Application for Certificate of Appropriateness for a City Landmark or Local Historic District

Re: Continuing Consultation for the Eliza Spring Outlet Daylighting Project, **Project review under Section 106 and the Antiquities Code of Texas**

Re: *Project review under Section 106 of the National Historic Preservation Act of 1966 and the Antiquities Code of Texas, Eliza Spring Outlet Daylighting Project, Zilker Amphitheater, Zilker Park, Austin, Travis County (106/USACE, NR, SAL)*

Figure 1. A) Current view of Eliza Spring Amphitheater looking northwest; B) Conceptual rendering of the project when complete from the same vantage. Note that the concept drawing does not include the proposed micropile reinforcing wall around the keyhole opening.

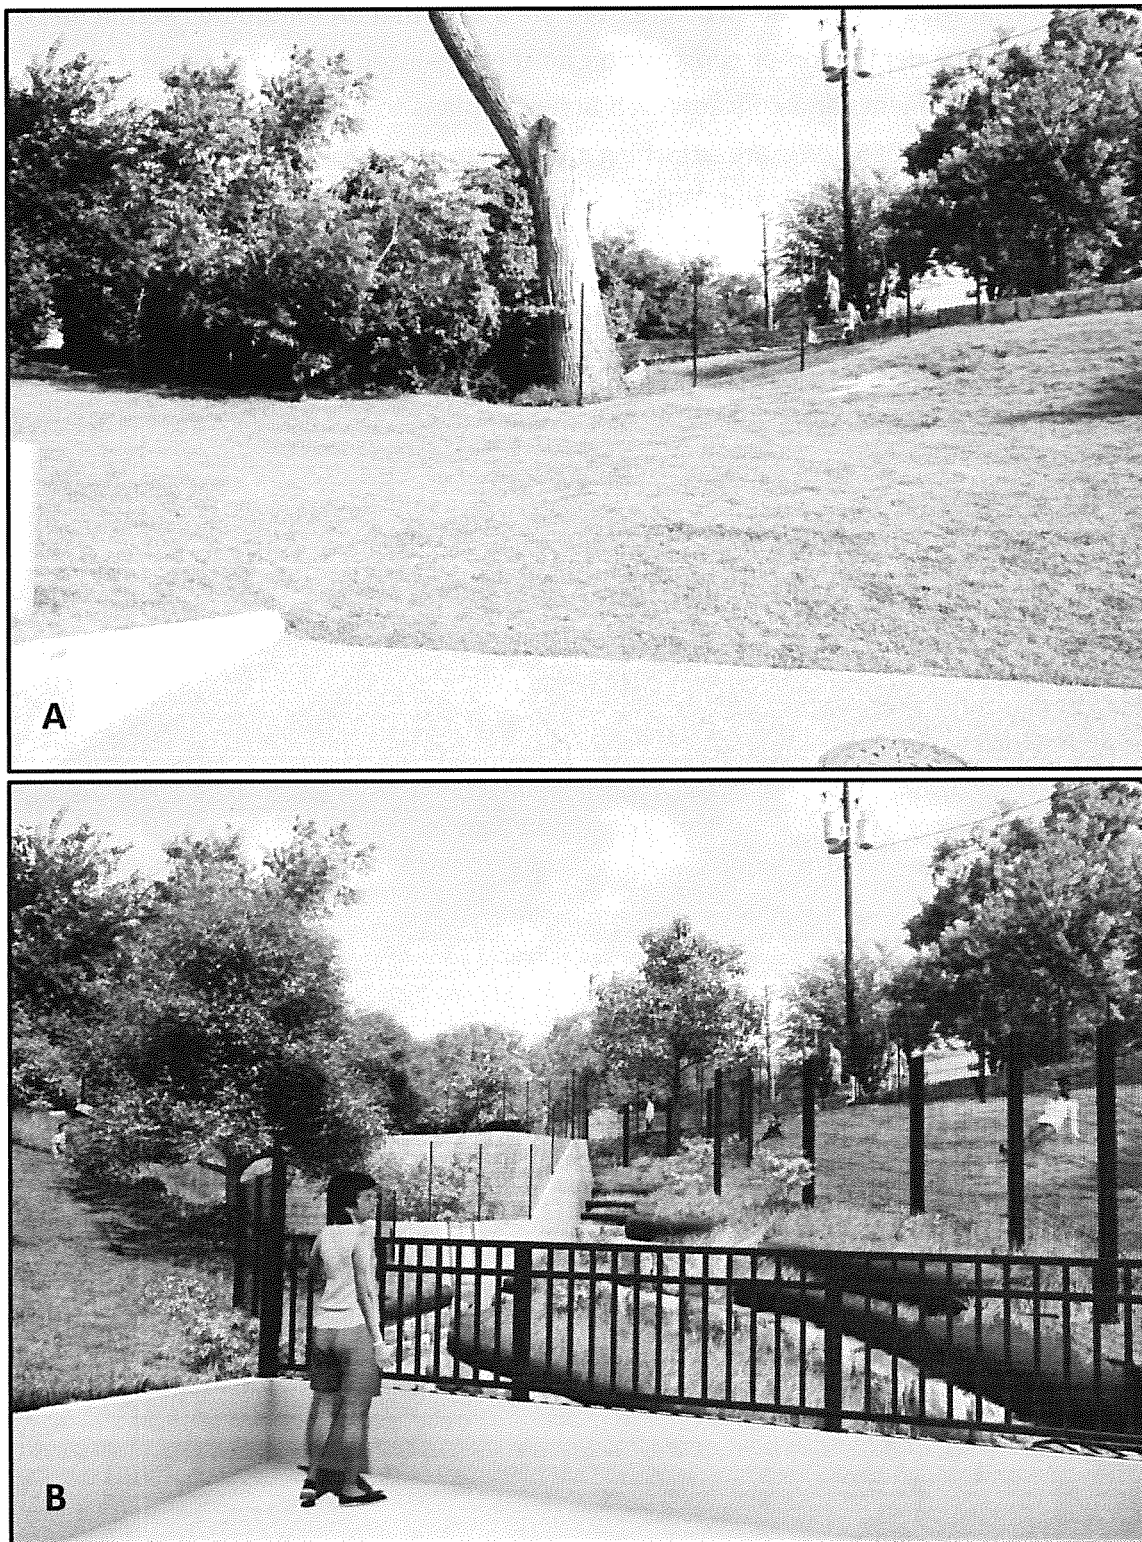
First, removing the earth fill around the structure to re-establish the open stream will expose portions of the amphitheater walls (an unknown portion of which were historically exposed) and potentially put the eastern end of the structure at risk of destabilizing. During the design process several solutions to this problem were considered, including stabilization of the exterior wall using a tie-back and anchor system. However, these solutions were ultimately rejected due to the high sensitivity of the Barton Springs Salamander habitat. Ultimately, to prevent damage or further deterioration of the 1903 structure, while minimizing possibility for impact to the endangered salamander habitat, the final design plans call for construction of a concrete and micropile wall on the exterior of the channel side of the amphitheater (see Plan Sheets C2.1 and S1.8). The wall would range in thickness from approximately 2.5 feet below grade, to less than 5 inches at the top of the amphitheater (see Plan Sheet S1.9). The wall would abut the amphitheater's eastern exterior around the keyhole opening but would not affect the integrity of the amphitheater's interior in any way. Although finish treatments have yet to be determined, these could involve matching concrete color or scoring to the original amphitheater materials, or developing another treatment that would be historically appropriate.

One other design element that we would like to call your attention to is a headwall gate in the keyhole opening (see Plan Sheet S1.4). Although not part of the original structure, the headwall gate would be necessary to control stream flow and water levels, and preserve salamander habitat. Although not integral to Zilker's original design for the amphitheater, we believe that the addition of the headwall gate would not adversely affect the structural or cultural integrity of the resource.
